PLAN REVIEW SHEET

2015-092

QuikTrip Corporation

Attachments: Bus stop pad detail

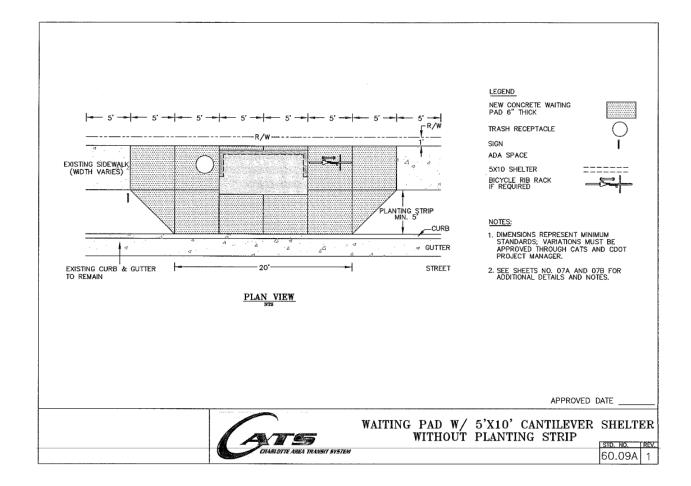
This site is located near an existing bus stop on The Plaza. The Petitioner is requested to provide and construct a shelter pad for a relocated bus stop on The Plaza between the two proposed driveways. Below is an image of the standard detail (60.09A) for the requested bus stop pad. Note that the design of the bus stop allows for future conversion to a shelter. The bicycle rack is optional. CATS will be responsible for installation and maintenance of the bench or shelter.
